ADDENDUM NO. 2 - OUTLINE AND SUMMARY INFORMATION

Project Name: Molecular Bioscience Renovation & Maintenance PPA No.: 22-0045
Location: Montana State University Bozeman Campus Date: August 27, 2026

*The Plans and Specification prepared by (**Bechtle Architects**) dated (**Jun. 03, 2026**), shall be clarified and added as follow. The bidder proposes to perform all the following clarifications or changes. It is understood that the Base Bid shall include any modification of Work or Additional Work that may be required by reason of the following change or clarifications.*

1 LVL 2 / DEMO PLAN - OVERALL
SCALE: 1/16" = 1'-0"

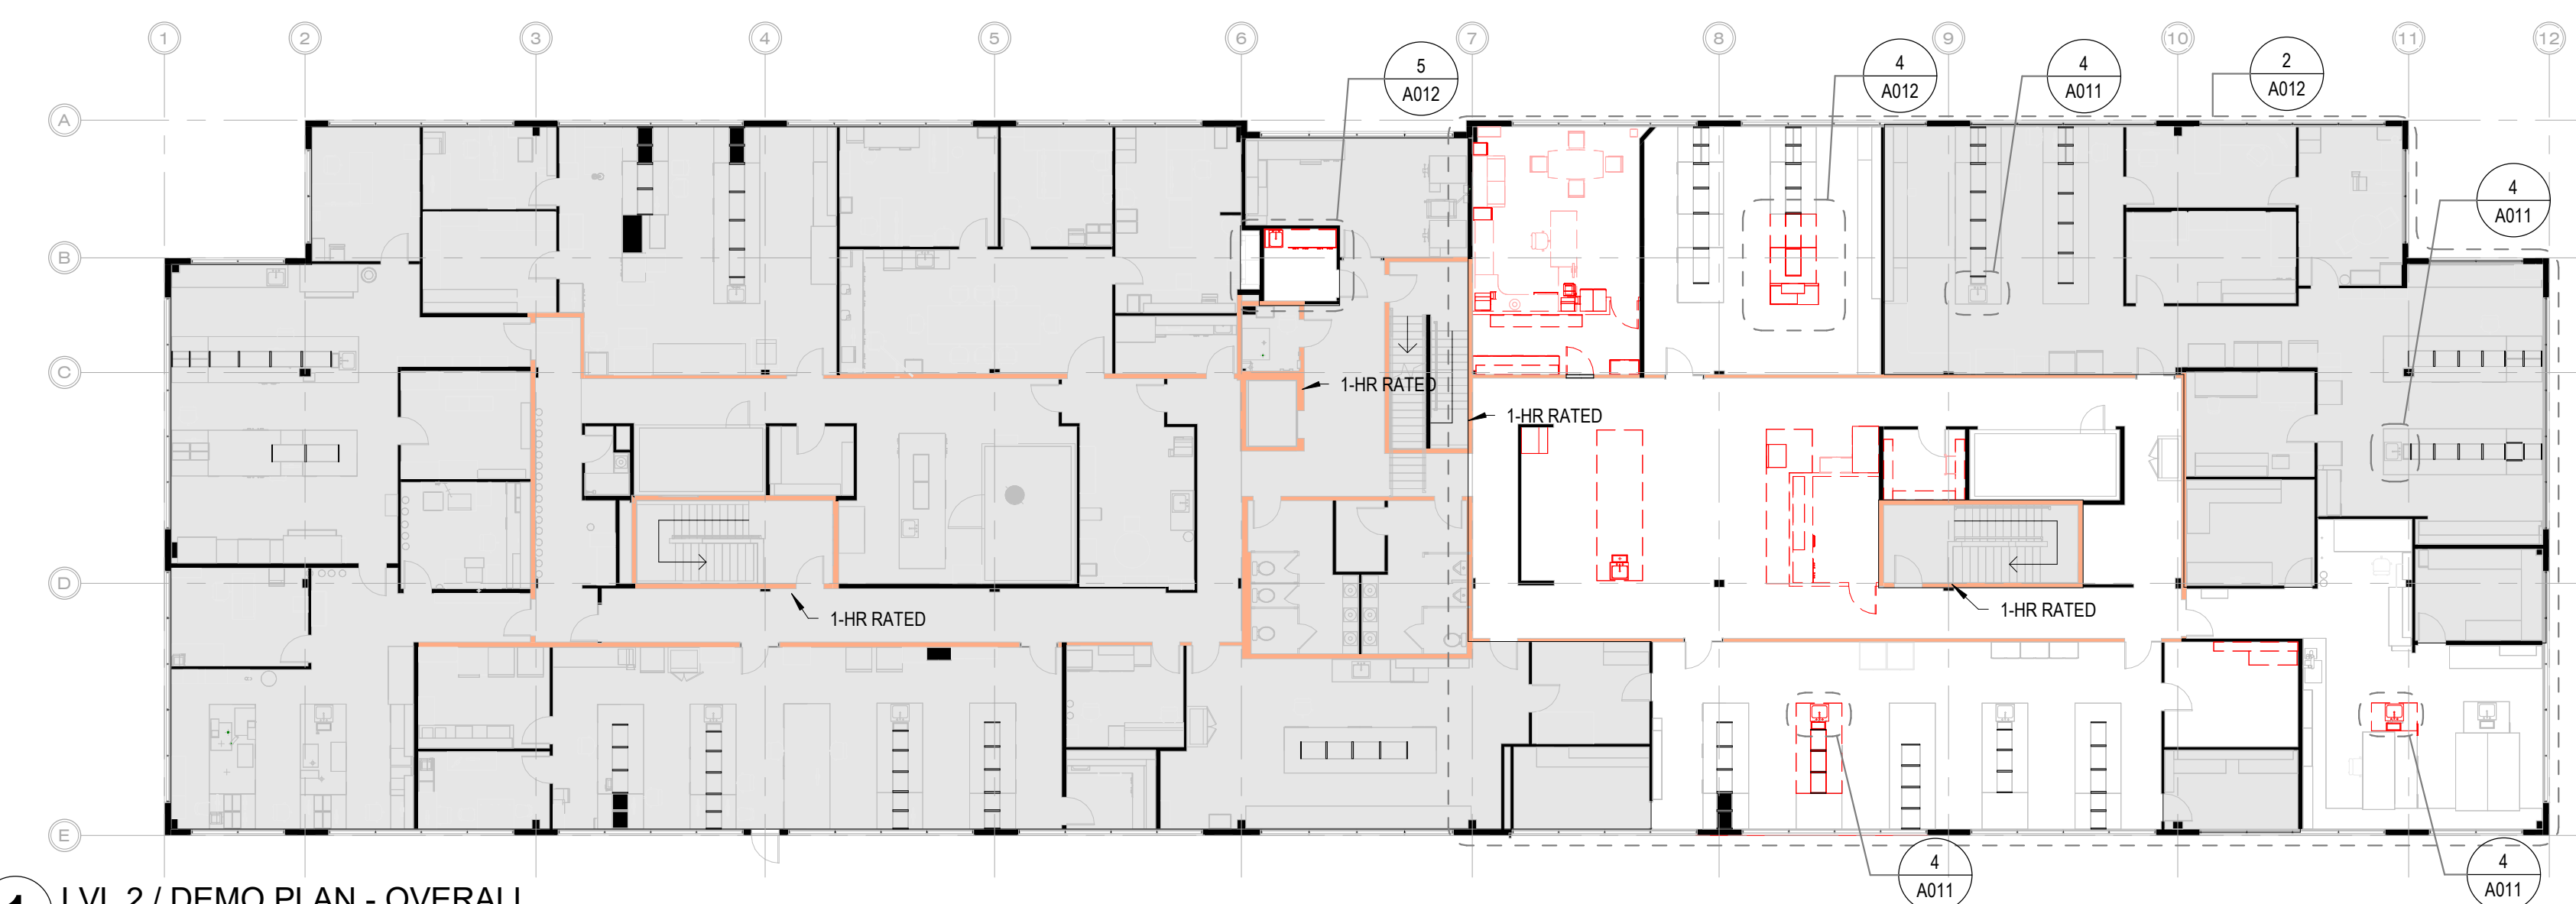
- 2) **A001** - CMU generator screen shall have a 24"Wx10"D strip footing, reinf w/ (2) #5 bar cont., #5 bar vertical @ 24" oc. Height of wall, provide bond beam mid hight of wall & top cap, joint reinf 9-gauge wire joint @ 16" o.c., solid gout cells. Slab for generator to match existing, assumed 6" concrete w/ #5 bar @ 24" o.c., dowel into existing slab/CMU wall.
- 1) **A012** – Labs 223 & 227 cabinetry graphics modified to indicate existing to remain. **A112** same areas graphics modified for cabinetry to remain. No work in these areas.
- 2) **A111-113** – note 6 for "DEEP CLEAN" to include all surfaces of cabinetry (inside & out), countertops, flooring & walls.
- 3) **A112** – new wall separating Office 222 & Bio Safety RM 221 shall be P1; 5/8" GWB, 2X4 WD STUDS @ 16" O.C., 3-1/2" Batt insul, 5/8" GWB.
 - a) **PLF-3**, in Lab 220, is an existing stainless steel sink to be relocated.

1 REMODEL PLAN - LEVEL 2 - OVERALL
SCALE: 1/16" = 1'-0"

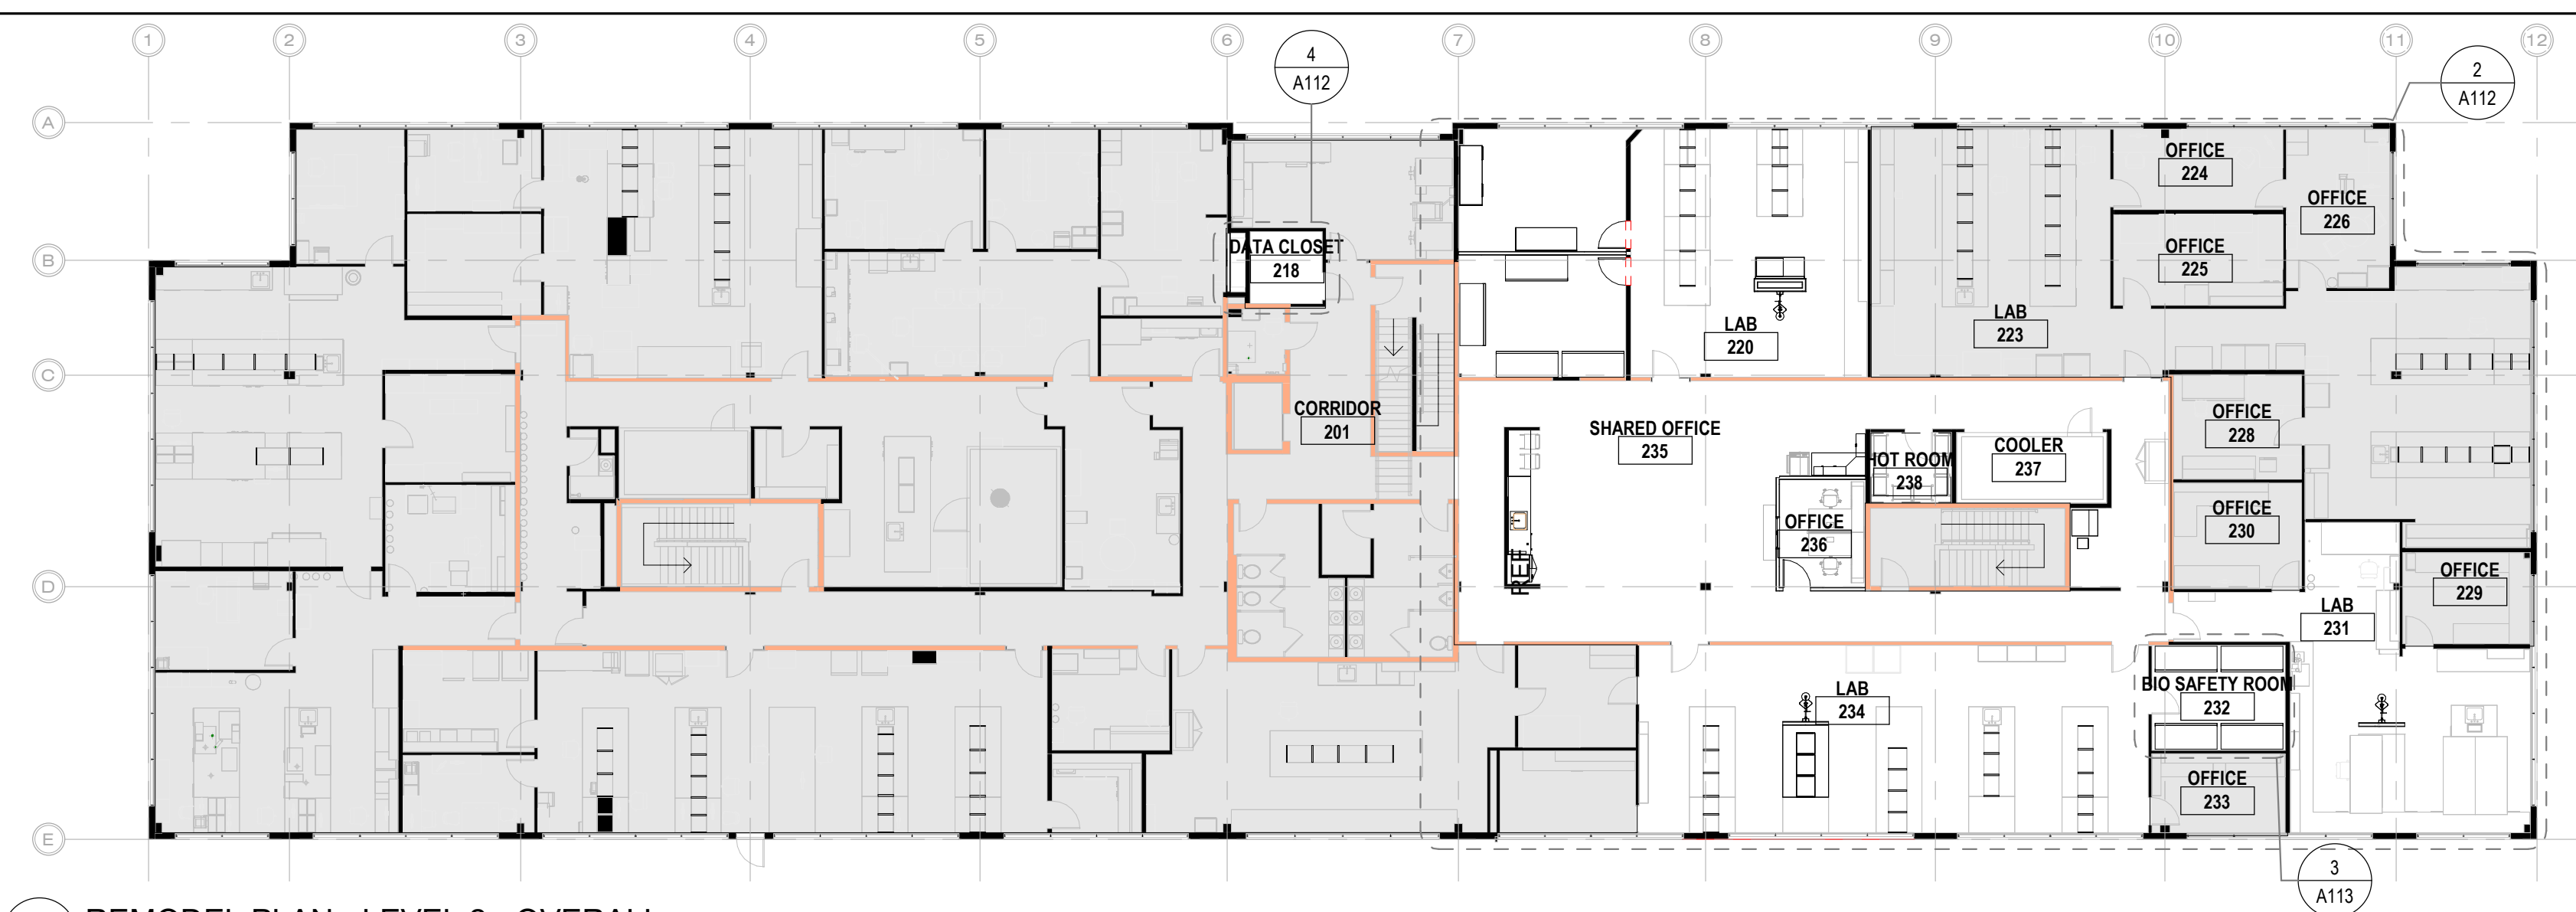
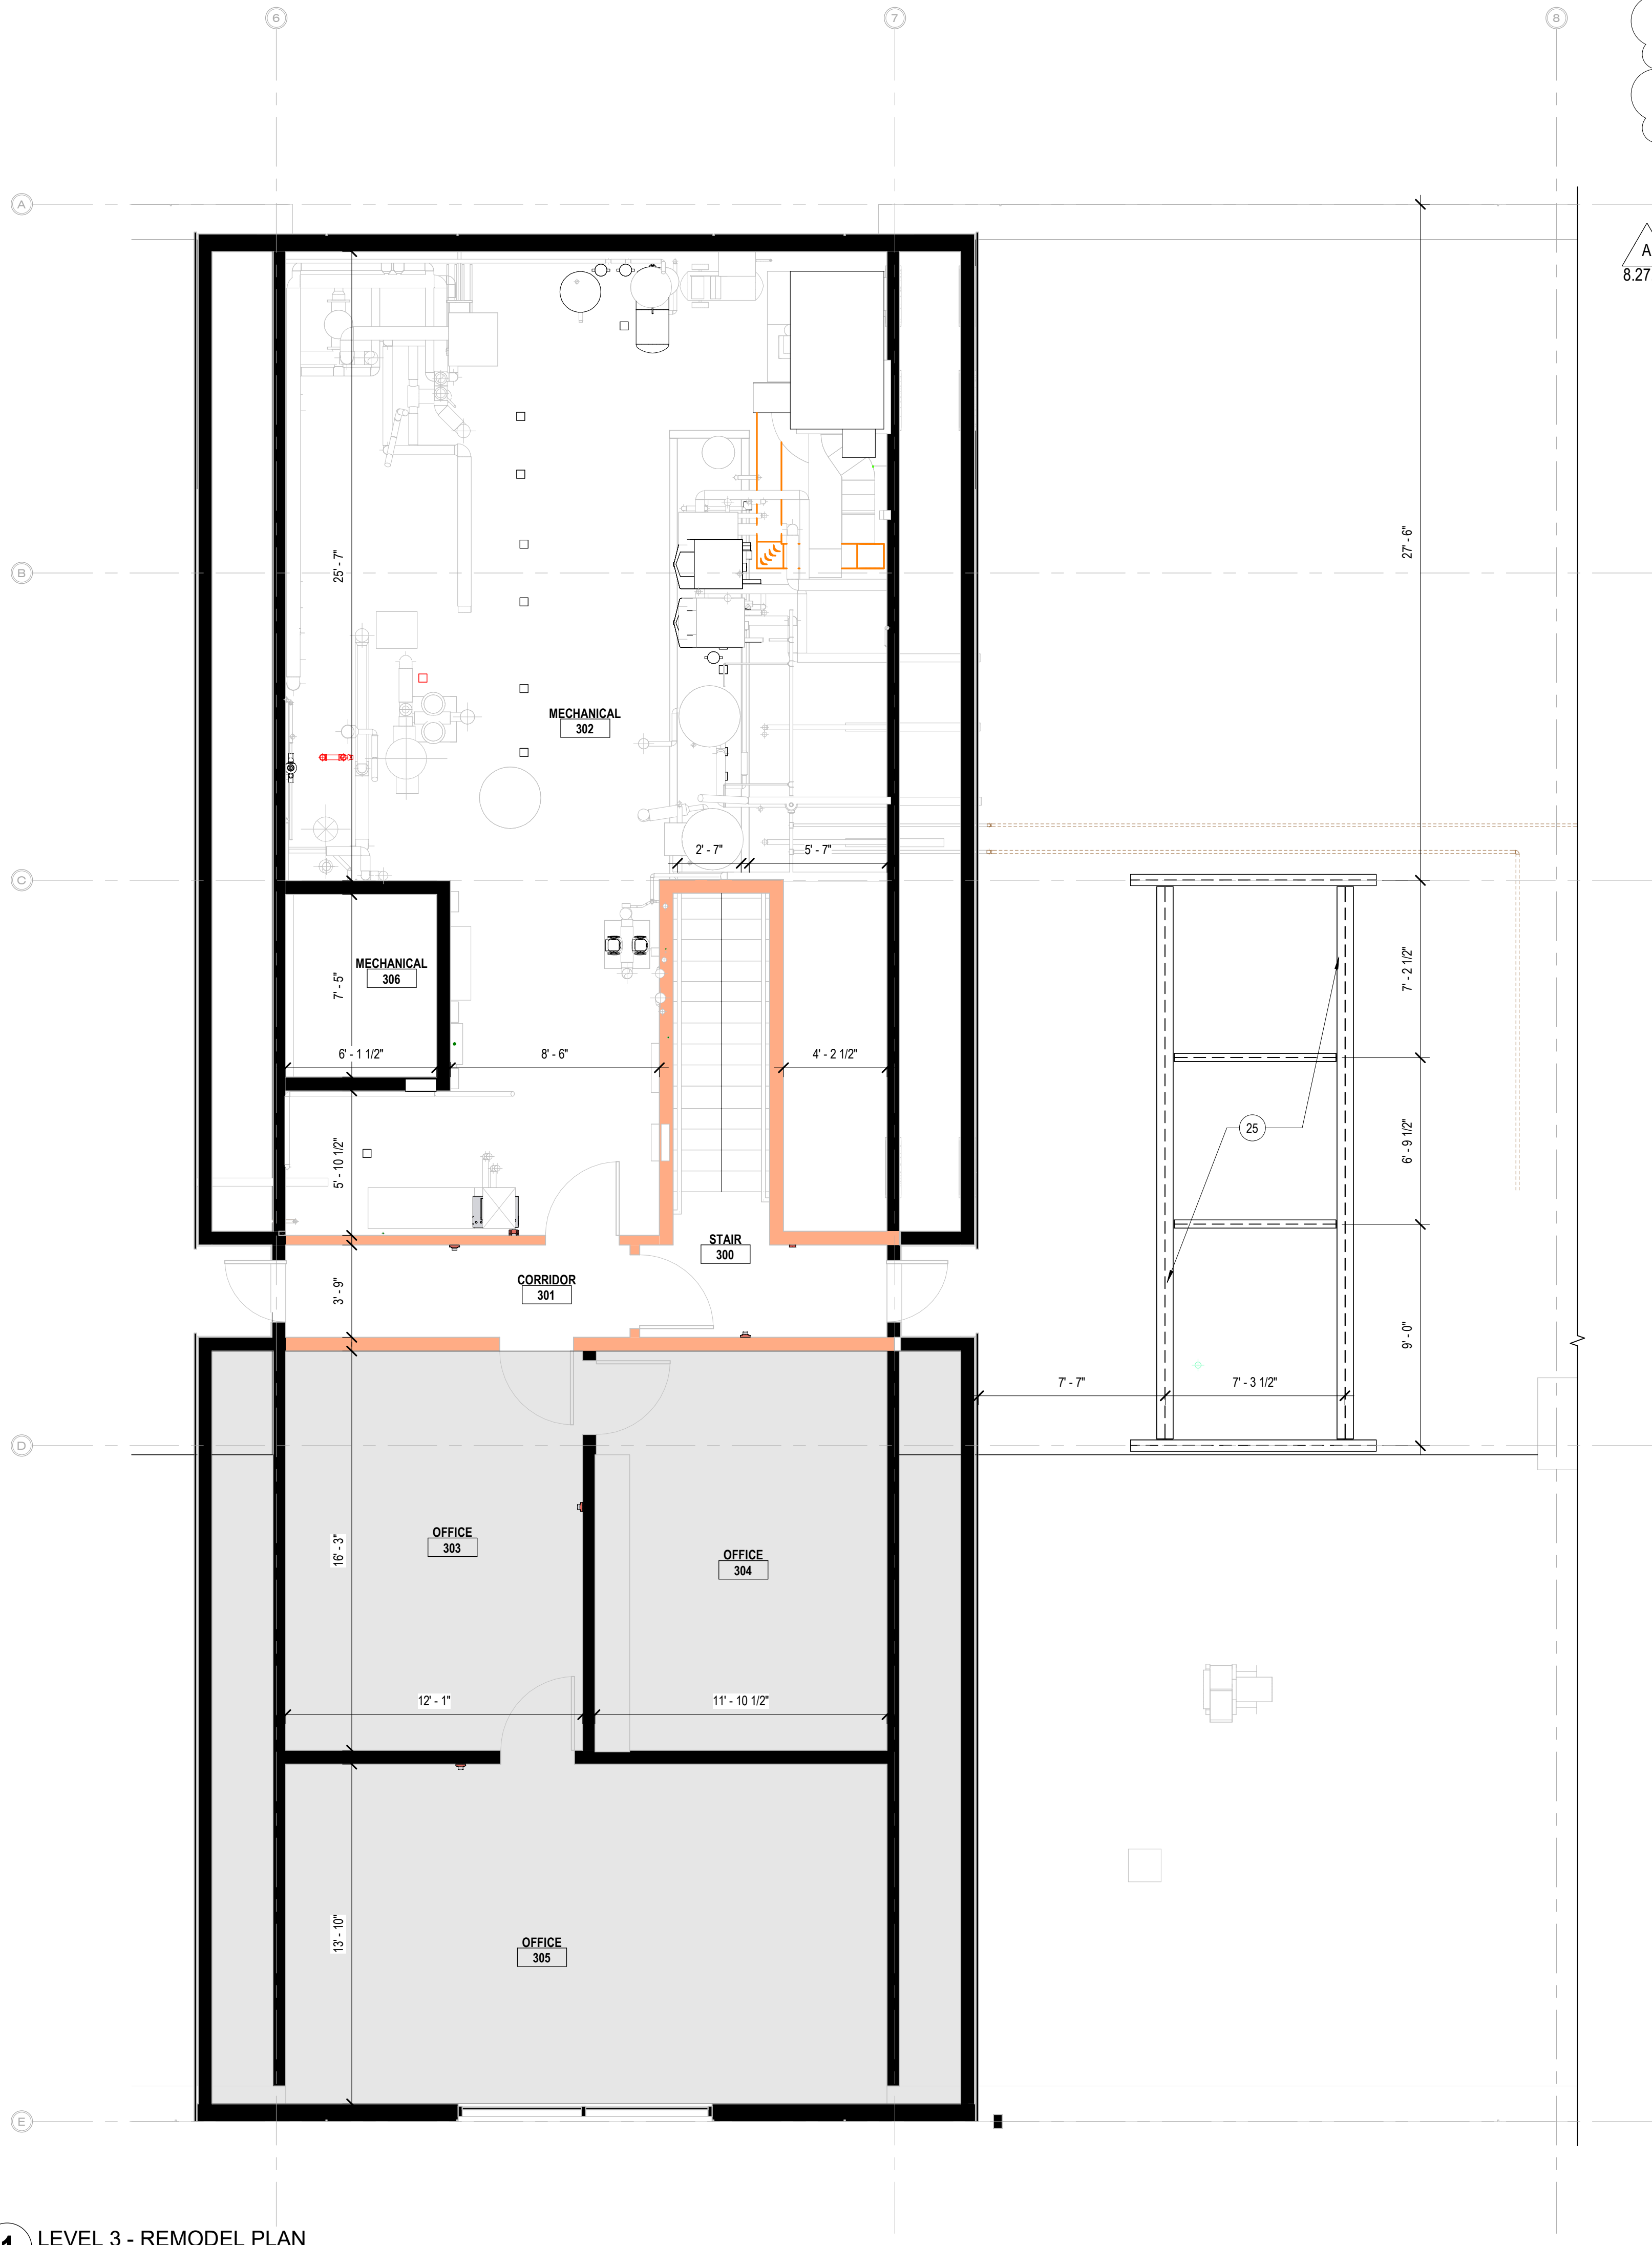
- b) At existing casework in Labs 220 and 231 where tops are partially demolished provide new edge banding on exposed countertop edge.
- 4) **A122** – New GWB ceiling to be supported by 2x6 joist @ 16" o.c.
- 5) **A123** – clarification on blown-in insulation at 3rd floor attic space.
- 6) **EL011** – Shows light fixtures that shall be replaced with an LED fixture. The scope was updated from add/alt pricing to be included in the bid. **E000** Language has been updated as part of Addendum #2.
